**KNOXVILLE/KNOX COUNTY METROPOLITAN PLANNING COMMISSION  
 USE ON REVIEW REPORT**

▶ **FILE #:** 6-J-18-UR

▶ **PROPOSED USE:** **Medical office**

▶ **APPROVE the Development Plan for a medical office building of approximately 21,260 square feet and the proposed sign plan, subject to 15 conditions.**

L1.0

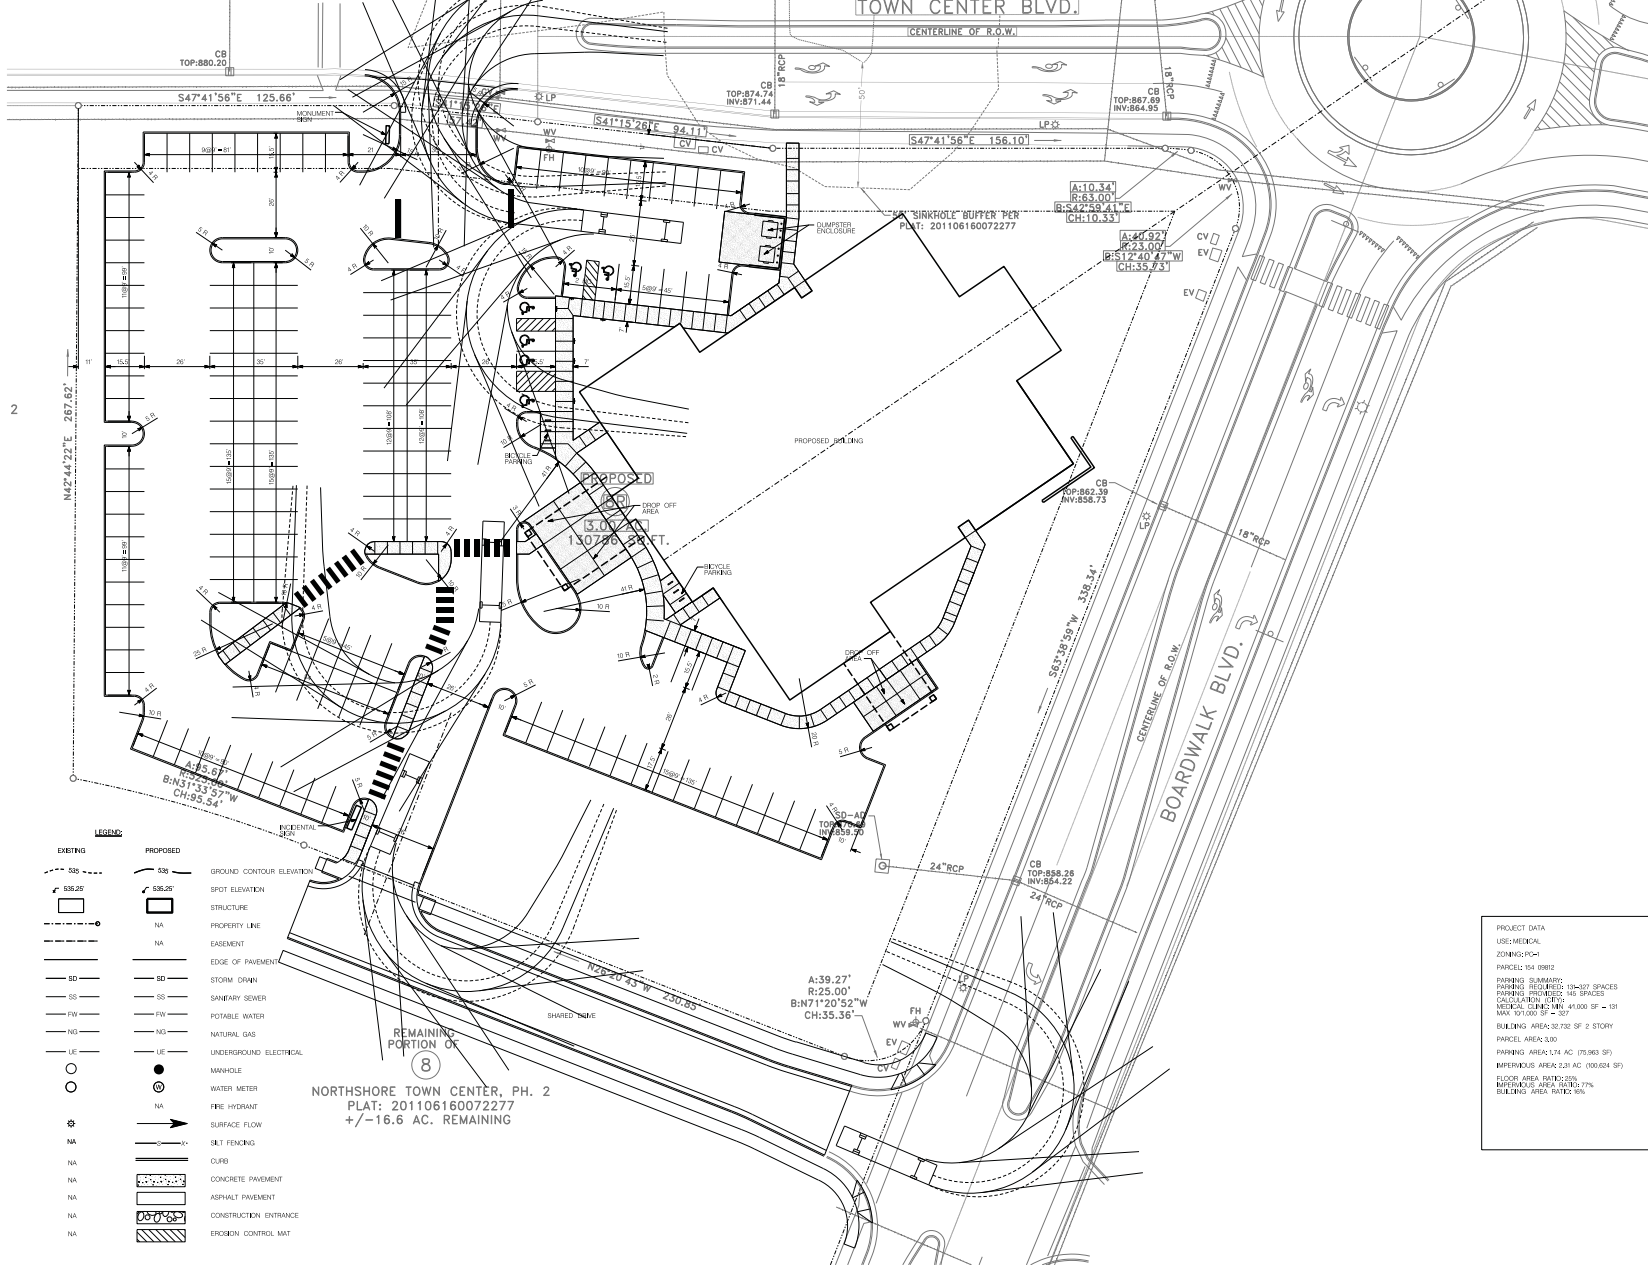
- 6) Installing all on-site and off-site (streetscape) landscaping as shown on the landscape plan (sheet L1.0) within six months of issuance of occupancy permit for the development.

DATE: 28 MAY 2018  
PROJECT NO.: 17009  
PROJ. MGR.: SHA  
**MPC01**

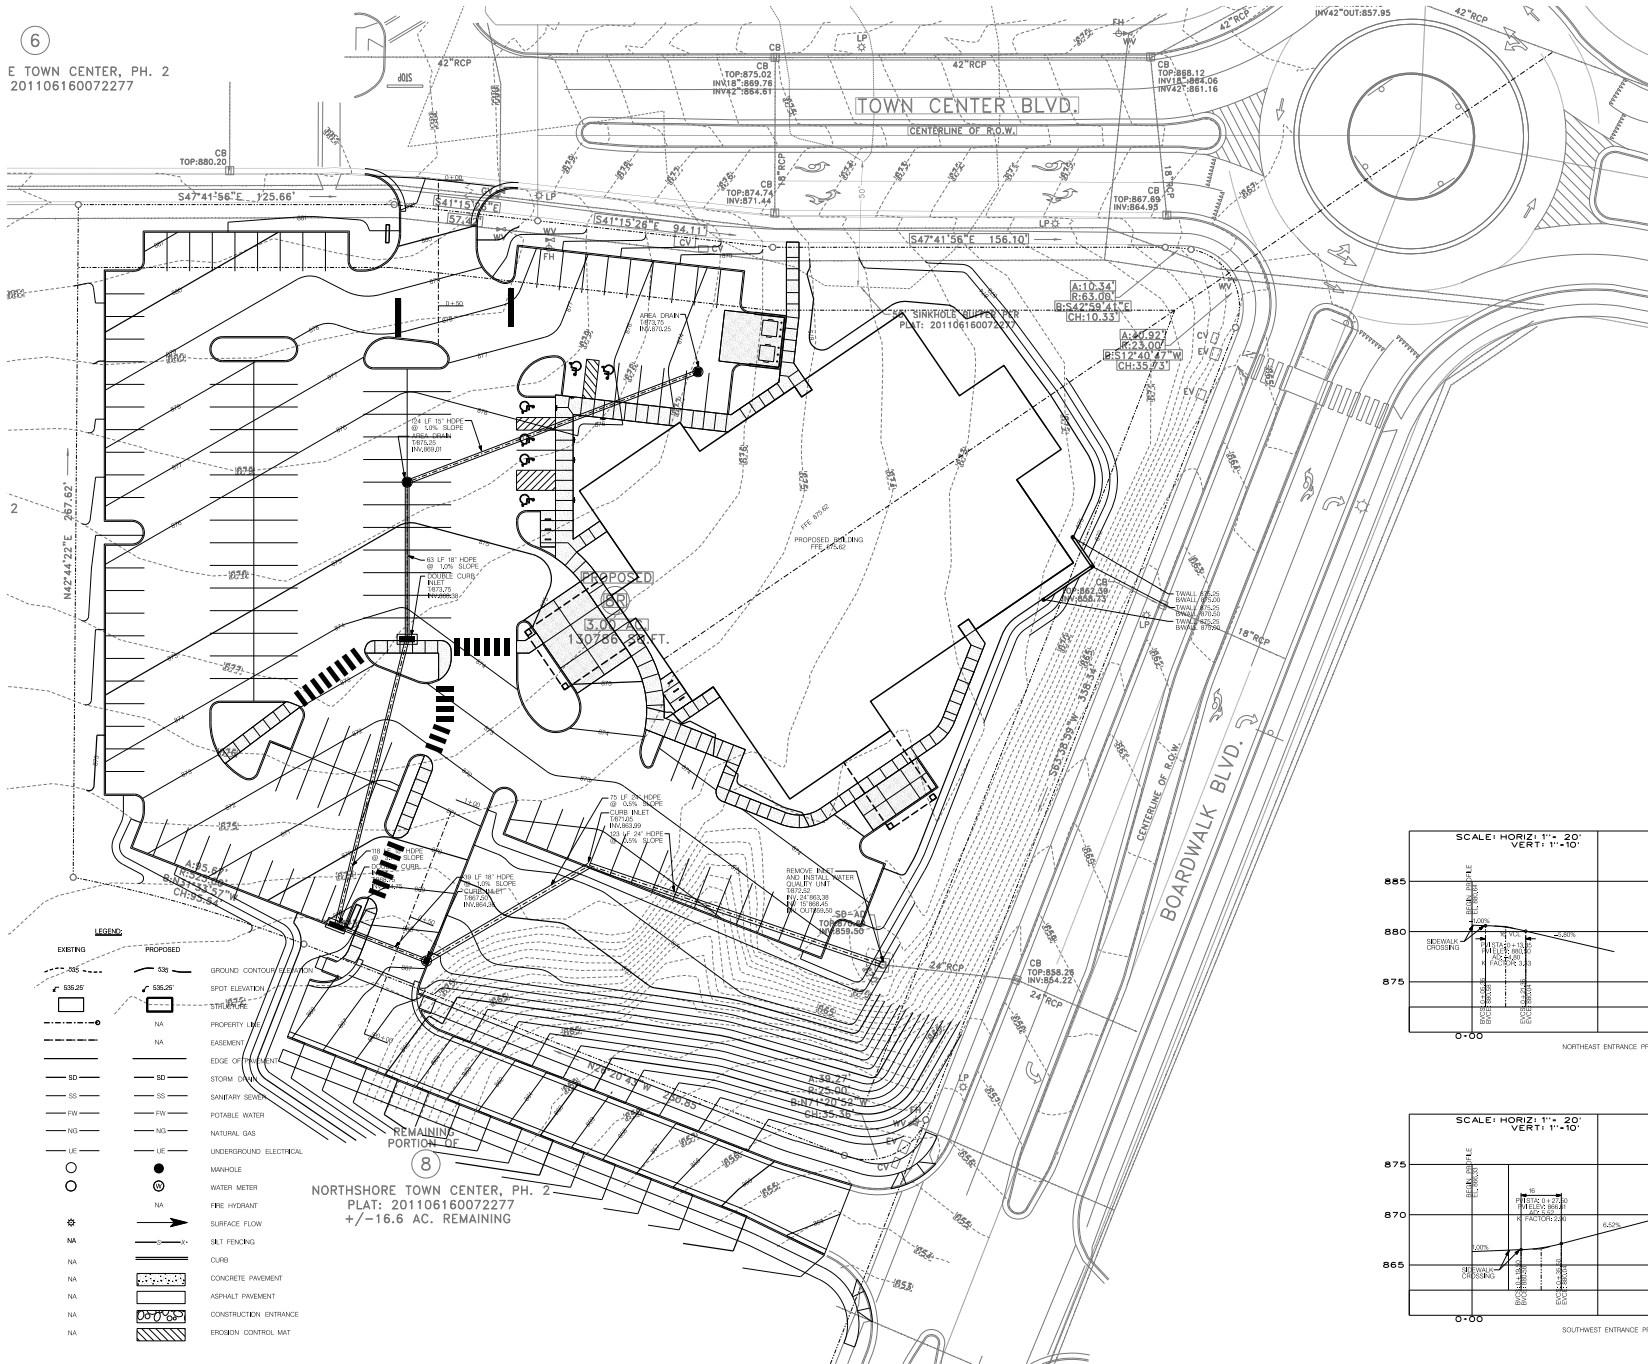
- 4) Installing the sidewalks and planting strip, street trees, and street lighting, as shown in the Concept Site Plan (MPC01), Landscape Plan (L1.0), and Site Illumination Plan (SE1.1). The location of new street trees shall be revised based on comments provided by staff, and reviewed and approved by Planning Commission staff and the City of Knoxville Urban Forester and Department of Engineering.
